The Baltimore City Department of Transportation is pleased to present the final 2015 Bike Master Plan and a summary of the final public review process. The below table provides a summary of all the comments collected from the final public review. The final public review included collecting and compiling comments from the public meeting held in January, the online public review webpage, comments sent to the DOT through email and letters from organizations that presented comments that reflected the review of an organization. For each comment submitted, the DOT also summarized a response and/or how each comment was addressed in the plan. All comments are provided in order by the date of which they were received.

**2015 Bike Master Plan Update
Final Public Comments
March 17, 2015**

Top: crossing Hillen at Windemere. Bottom: crossing Hillen at Lakeside.

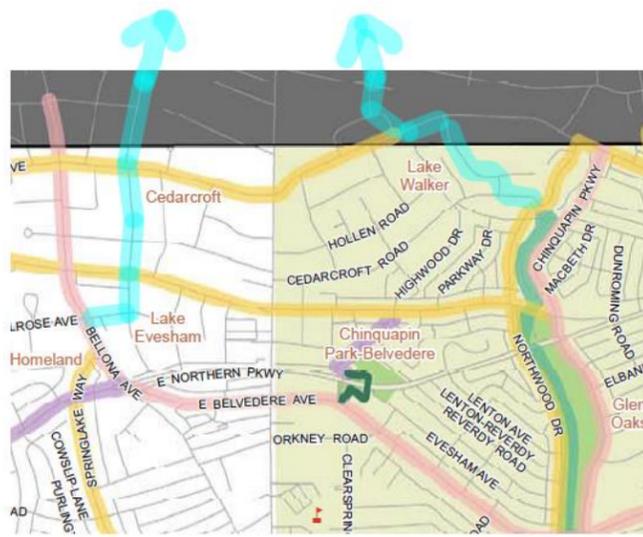
b. You have Windemere Avenue (two blocks north of 33rd) as a proposed Neighborhood Route between Memorial Stadium and Lake Montebello. I ride this route frequently, and I prefer Lakeside Avenue (one block north of 33rd), for the following reasons:

- 1) it's easier to cross Loch Raven and the Alameda on Lakeside, because traffic coming north from 33rd hasn't had as much time to speed up, and southbound traffic is slowing down as it approaches 33rd;
- 2) Windemere has a little more elevation change; it's not much of a hill, but it is noticeable.
- 3) Since there's currently no path connecting Hillen to Lake Montebello, using Lakeside means one less block of riding on busy Hillen.

4) In the future, building a short path from Hillen to Lake Montebello would be better at Lakeside, because crossing Hillen at Windemere to get to Lake Montebello, you'll have to go up a steep bank; crossing Hillen at Lakeside, it's pretty flat.

This is a great observation. Windemere was originally chosen because it is a direct continuation of 34th Street. For planning purposes we have added a proposed route on Lakeside Avenue in addition to Windemere Road.

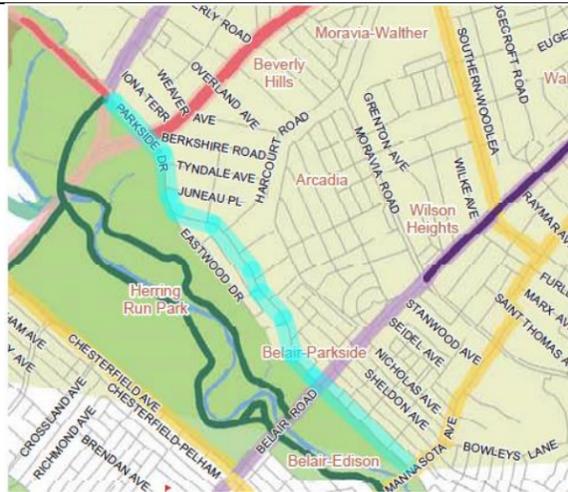
There's a need for a way to ride between the Charles Village area and Towson, avoiding the horrible York Road. There are streets in the city that could be strung together as bike boulevards (Old York/43rd/Northwood to the east of York, Greenway/Millbrook/Springlake to the west); the main question marks are in the county. If there are some ideas where the Charles Village/Towson Corridor will go in the county, the city's master plan should show where the city's part will connect. For example, if the route in the county is going to be Pinehurst/Heathfield/Osler, then the city's part of Pinehurst should be in the plan. If the route in the county is going to be east of York, then Woodson and Holly in the city might be involved.

The Plan focuses on improvements that need to occur within the City to create a well-connected network within the City. The DOT, however, recognizes better communication with the County is important as more and more bike facilities are built in the County. For planning purposes, we have added the suggested routes as minor routes, but future coordination with the county and the adjacent Baltimore City communities can help better determine which streets in this area are most appropriate to make a connection to key destinations (like Towson).

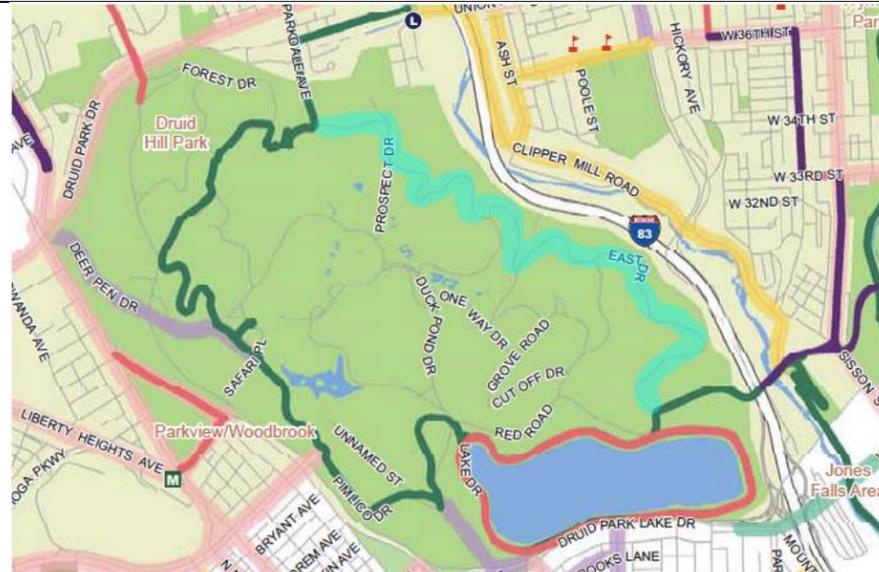
I think Parkside Drive (just northeast of Herring Run Park) would be a good Neighborhood Route; it's the best on-street way to get from the Belair-Parkside neighborhood to Morgan State. The MUPs in Herring Run Park are great recreational paths, but for transportation, Parkside is a more direct and less hilly route, with fairly light traffic.

The DOT agrees, the suggested route has been added as a neighborhood route.

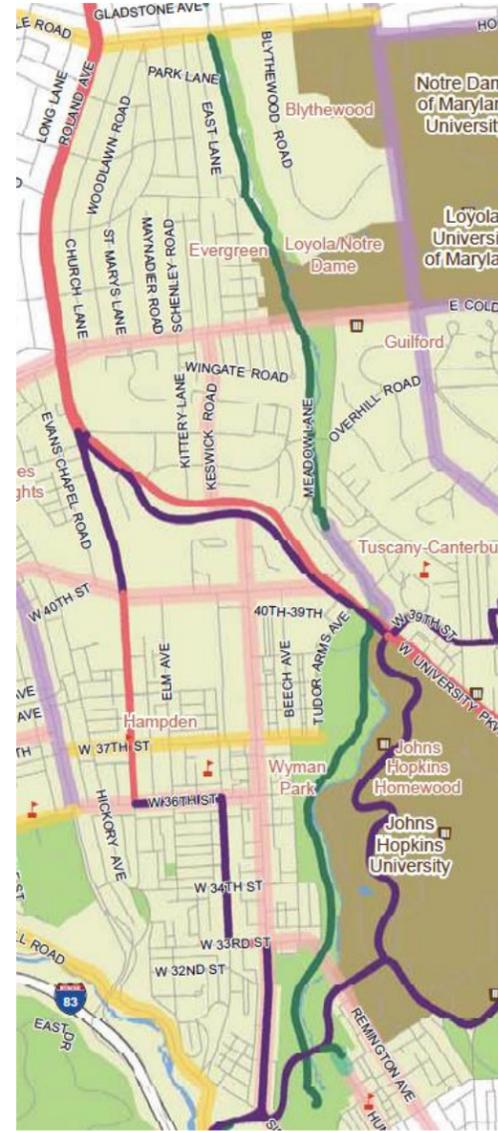
I know you don't want to map every little path in every park, but Poplar Drive/Prospect Drive/Mountain Pass/Red Road in Druid Hill Park are mostly closed to cars (I think Red Road may be open). They get used a lot as MUPs, although I don't know whether that's their official status, or if they're officially park maintenance roads. But they

make a nice hilly loop with the JFT in the park, and you might want to put them on the map.
[Also], cars aren't allowed on the road around Druid Lake, so shouldn't it be a dark green line, not red?

While we understand these roads would function well as MUPs, they are not regularly maintained or patrolled like other trails due to budget constraints so we do not want to classify it officially an existing trail without that commitment. The loop around Druid Hill Park is a trail, not a main route, so we have adjusted the mapping to reflect this.

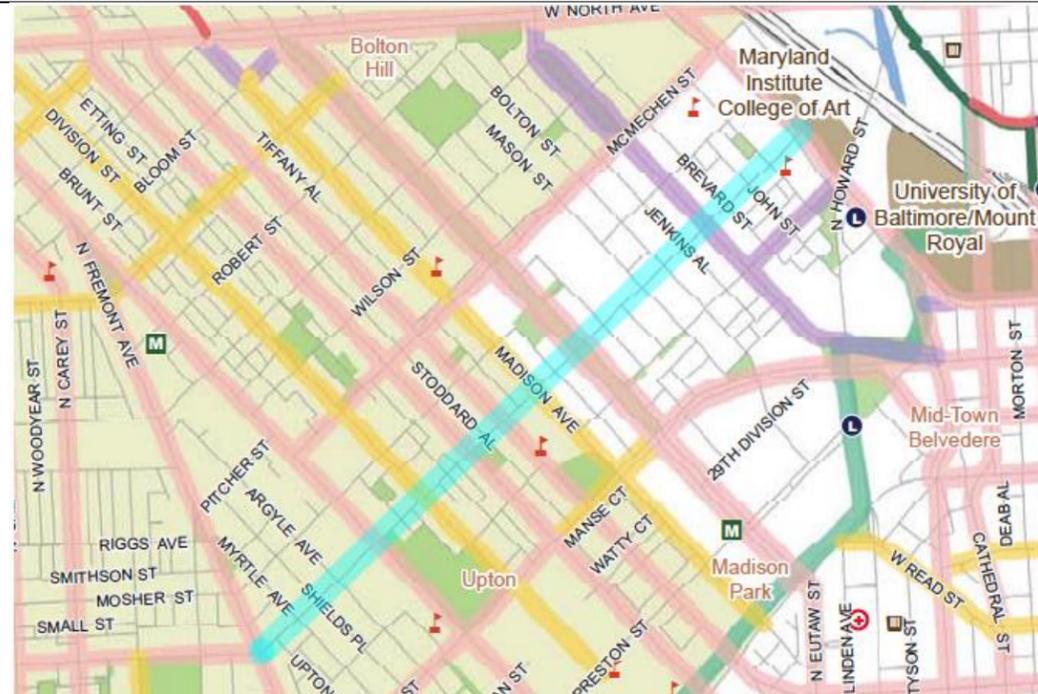
There is no path west of the blue line.

You've got a dark green line going through Dickeyville and on Purnell Drive. I'd love to see the Dickeyville Trail extended parallel to Purnell Drive, but it currently ends at the east end of Dickeyville.

Agreed, this was a mapping oversight. We have ended the trail at Wethersville Road, the location you indicate on the map, and continued it as a proposed trail.

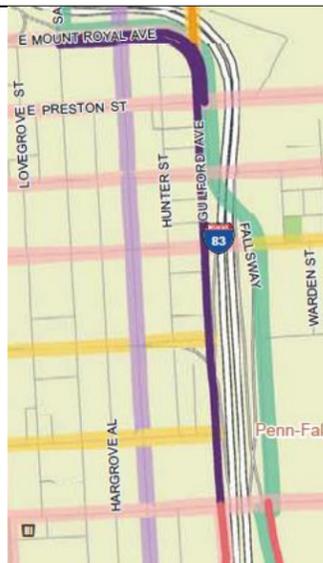
With the lovely Guilford only one block away, I don't know why you'd want to make Calvert a Minor Route; it's narrow and busy.

The DOT can see where Guilford Avenue is a more desired route for most riders. The minor route identified on Calvert Street could help create redundancy and make multiple north-south options through an area with a lot of college students and young professionals. The DOT recognizes a minor route on Calvert Street would be dependent upon other traffic calming measures.

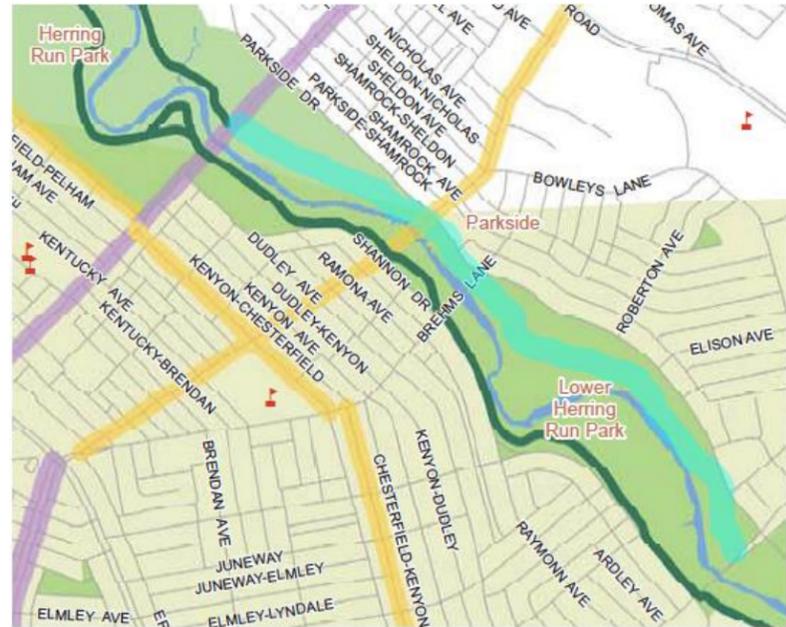
Isn't the JFT here complete enough to get a dark green line?

Yes, this was a mapping oversight. The trail has been changed from proposed to existing.

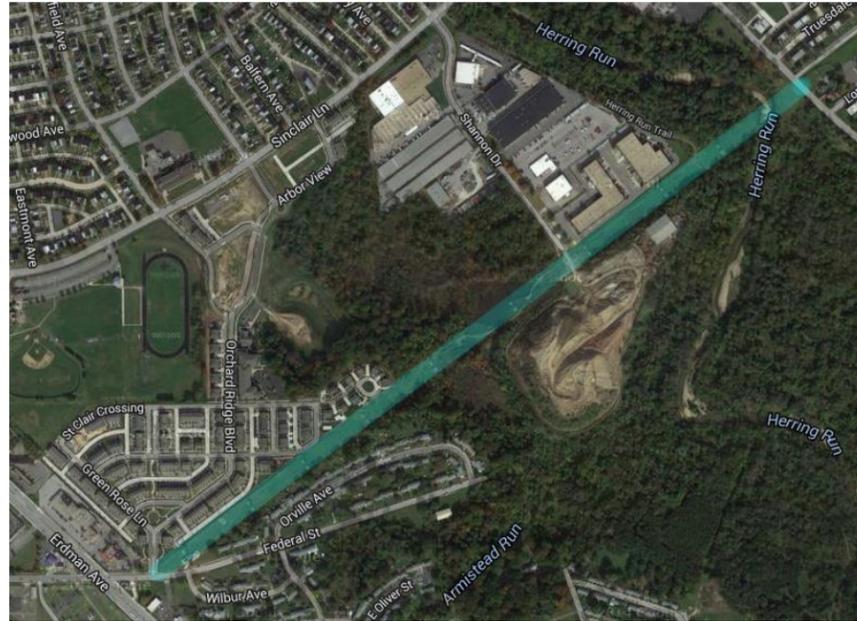
The portion of the Herring Run Trail on the north side of Herring Run is being extended from Belair to Sinclair and is under construction now, so you can add a light green line there.

This proposed trail has been added.

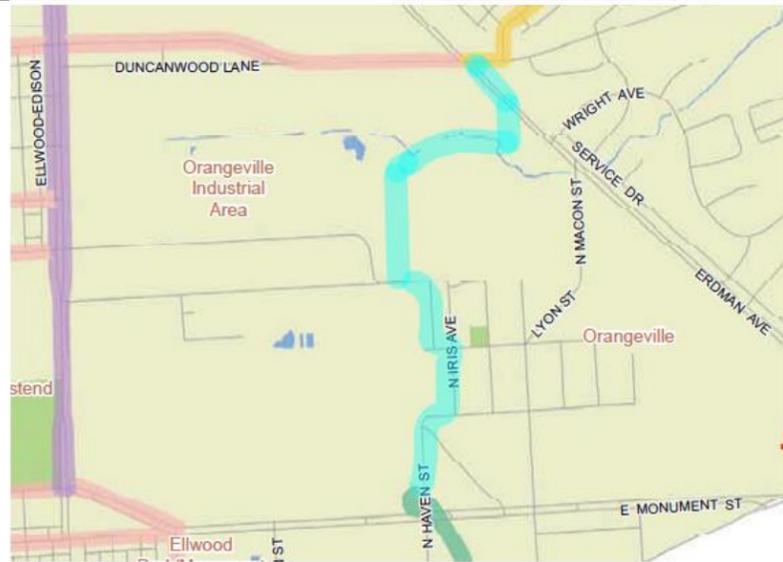
Since you're proposing a trail under the BGE power lines going northeast from Herring Run (a great idea), why not extend it across Herring Run and down to Erdman? This would be a great way for people from the Orchard Ridge development and Armistead Gardens to get to the Herring Run Trail and BGE Trail.

This proposed trail has been added.

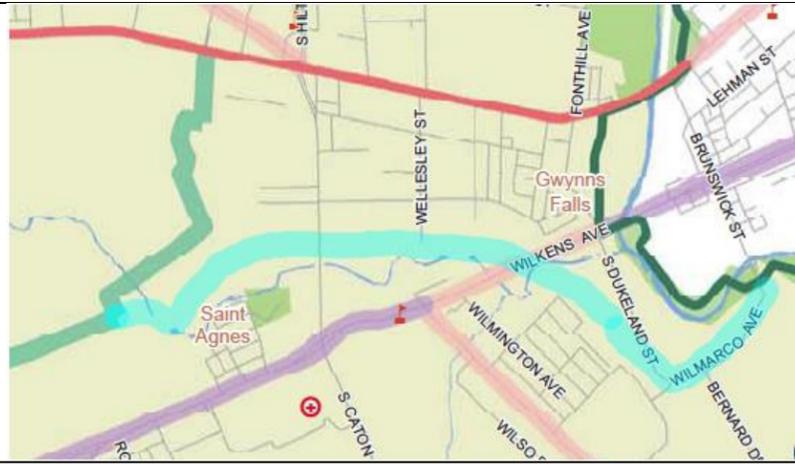
Whether or not you extend the BGE Trail to Erdman, it would be great to connect Erdman to the north end of the Highlandtown High Line. The path would go around the BGE substation at Federal and Erdman, then go under the Amtrak tracks via the culvert that carries Armistead Run under the tracks. This stone culvert is about 10 feet high at the center, and Armistead Run is a trickle a few inches deep; a path suspended a couple of feet above the stream would provide plenty of room for the stream underneath and sufficient headspace above. Once under the tracks, the path could follow the BGE line to Chase Street, and then the very quiet streets of Orangeville to the High Line.

This proposed trail has been added.

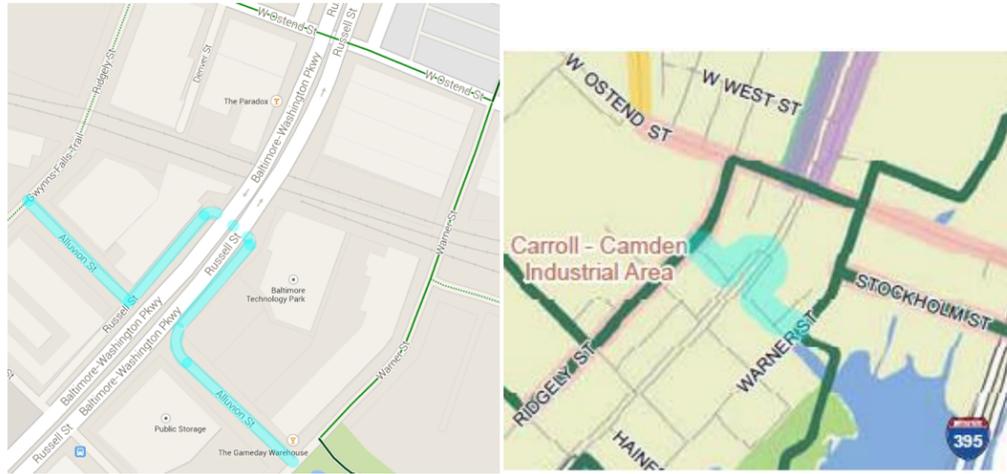
Joh Avenue is a nice way to get across I-95, much better than Caton. In Violetville, it's a quiet residential street. Between Benson Avenue and Caton Avenue it's two lanes in each direction, and I don't think it gets a ton of traffic, so it could be one traffic lane in each direction plus bike lanes plus parking on one side without too much squabbling. I think the two outer lanes are parking lanes, but hardly anyone parks in them, since it's an area of light industry with their own parking lots. On the west end, it could connect to Wilkins via Coolidge and Rock Hill; on the east end, it could connect to Georgetown Road, another quiet street that would make a good neighborhood route.

This proposed route has been added.

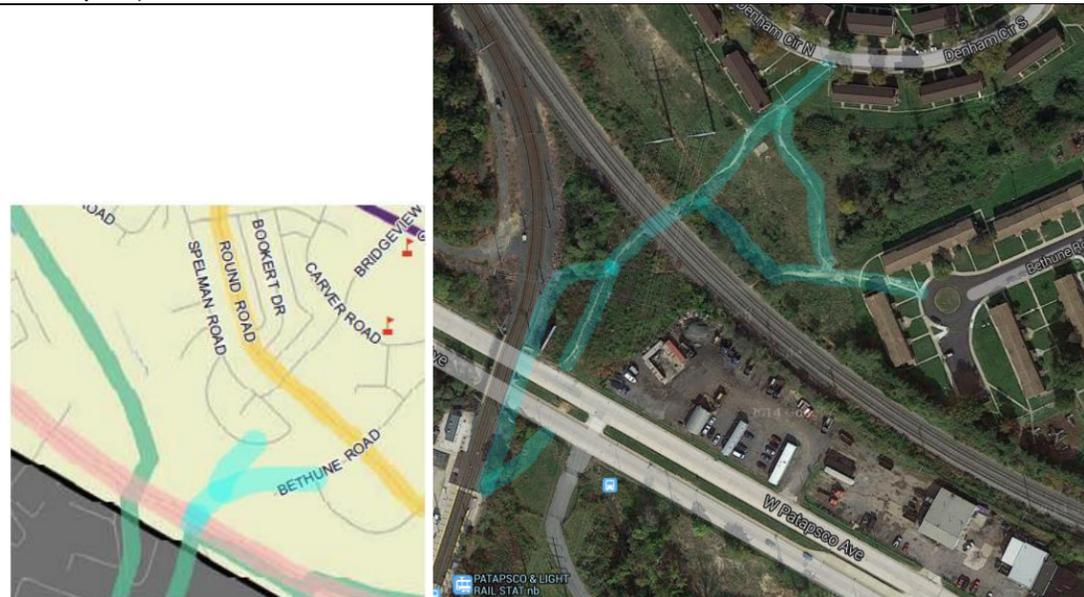
The bike/ped overpass over I-95 between Kane Street and Quinton Street should get a dark green line; it's a very useful bike shortcut.

Thanks for pointing this out, we have added the existing facility.

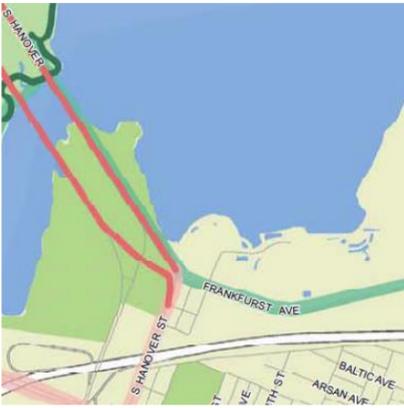
There are a bunch of very heavily used desire paths from Cherry Hill to the Baltimore Heights light rail station and Patapsco Avenue. Many people walk on the light rail bridge over Patapsco Ave. to the light rail station, which is a tragedy waiting to happen; others walk down to Patapsco Avenue to catch buses. An MUP here would get a ton of use, easily hundreds of people a day. If the people in Baltimore Heights object to making it easier for Cherry Hillians to get to their neighborhood, too bad; the entire project could be built within the city limits (by about 20 feet). While this would benefit a lot of pedestrians, it would also be an important link to get to the trail AA County is building alongside the light rail tracks, especially if Baltimore County converts the power line access road in South West Regional Park to an MUP.

This proposed trail has been added.

Figure 2: Annual number of bicycle-related crashes by type

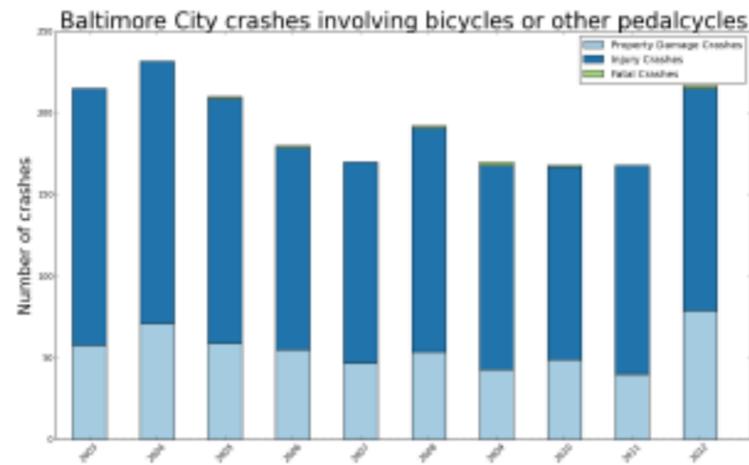
Section III. Current Conditions in Baltimore, F. High Crash Areas (pg 14) We suggest providing a table or figure of crash data from 2006 to 2011, broken out by severity of injury and age group of cyclist. This is worth including because it supports text in this section saying that children are involved in more crashes than other age groups. The expanded date range would also cover years since the last master plan was implemented. We have created such a figure using the bicycle crash data supplied by the city. You are free to use our plots if you like (with attribution). We can send you a high-resolution image.

While the DOT appreciates this suggestion, the data range is inconsistent with the mapping and other data provided in the Plan. There is also a table in the mapping that breaks down the crash data mapped by crash severity.
